292-D-6  
2004-0102  
55 waver  
ave.  
lifestyle  
fitness

**CITY OF PORTLAND, MAINE  
DEVELOPMENT REVIEW APPLICATION  
PLANNING DEPARTMENT PROCESSING FORM  
Planning Copy**

Lifestyles Fitness Center

Subject:       **Building and Parking Expansion  
Lifestyle Fitness Center  
55 Warren Avenue, Portland, Maine  
Response to Comment Letter of 8-26-04**

SHEET NO.  
 CI

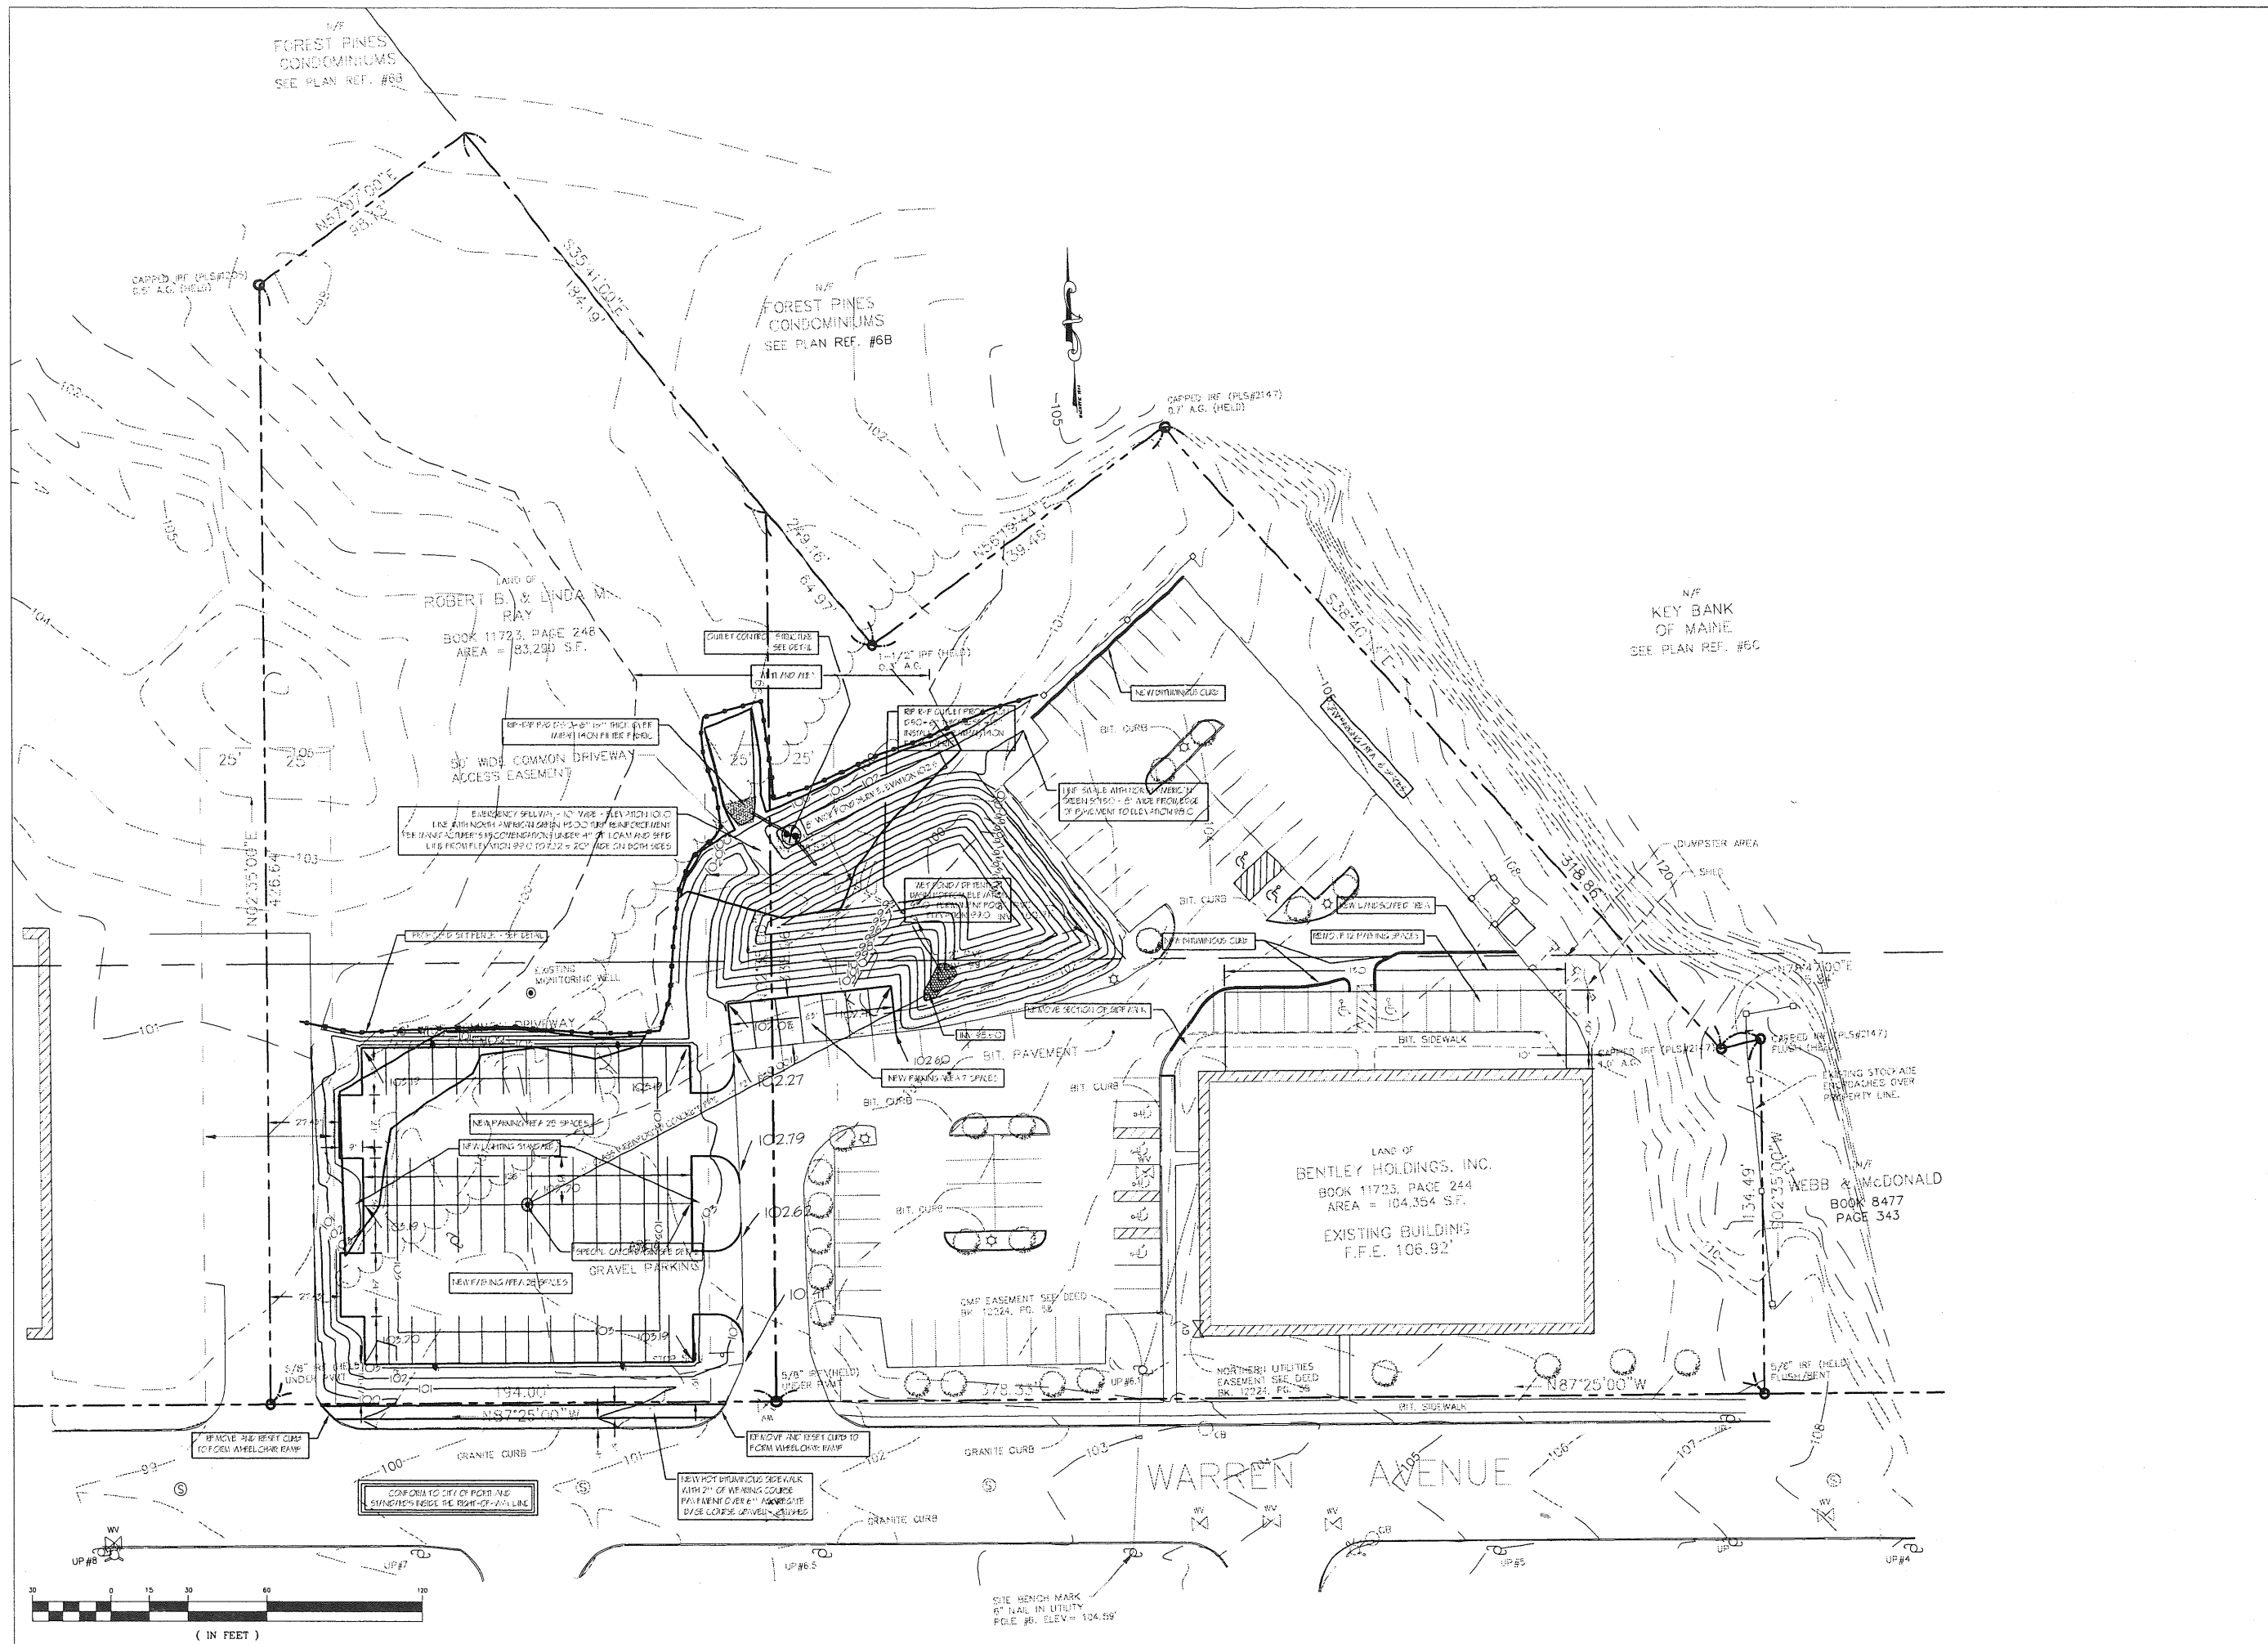
- a. It appears that there is not sufficient cover over the storm drain from the proposed catch basin. Sebago Technics recommends that the pipe be over excavated to a depth below typical frost, and a clean backfill material placed in the bottom and then a depth of one foot of stones be set below the pipe, instead of six inches. This will assist in limiting frost heaves at the pipe location and will provide improved structural integrity of the pipe.

- a. The 16 temporary parking spaces along the eastern rear have deemed to be removed. The plan needs to state that fact and show the area as loamed and seeded. This leaves the applicant with one additional space over the requirement.

- c. The plan shall indicate snow storage locations. We recommend the area noted above, the area reclaimed to the east and some area north of the new parking lot. No snow per DEP design standards may be placed directly in the wetpond.

- d. The handicap space closest to the corner on the handicap-parking row shall be eliminated. This spot is not ideal so close to the corner. Furthermore, we recommend an accessible ramp on the corner for the handicapped, and parking lot pedestrians. Please also be sure that sidewalks for all lead to the intended main entrance, the plans are not clear if the sidewalks from Warren Avenue still connect to an entrance door. Elimination of one handicap space still provides enough spaces to meet ADA standards.

4. Mark Gray of this office discussed the issue of the potential for frost heaving of the soil under the proposed 18" Class V reinforced concrete storm drain lead with Jim Seymour yesterday. A 4' wide, 2" thick closed cell polystyrene insulation is now proposed at the bottom of the bedding material for the pipe. This change is shown on the trench section detail on sheet C1.

5. The 8" roof lead has been shortened where it enters the pond and rip-rap has been added. See sheet C1.
6. The 16 temporary parking spaces on the east side of the existing north parking lot have been eliminated and the area has been shown to be restored with 4" of loam and seed. See sheet C1.

7. The parking spaces closest to the pond at the end of the approach drive have been designated employee parking spaces. See sheet C1.
8. Snow storage locations have been shown on sheet C1.

9. The handicapped space at the north end of the row immediately west of the existing building has had its handicapped designation removed. A 5' wide sidewalk has been restored to the
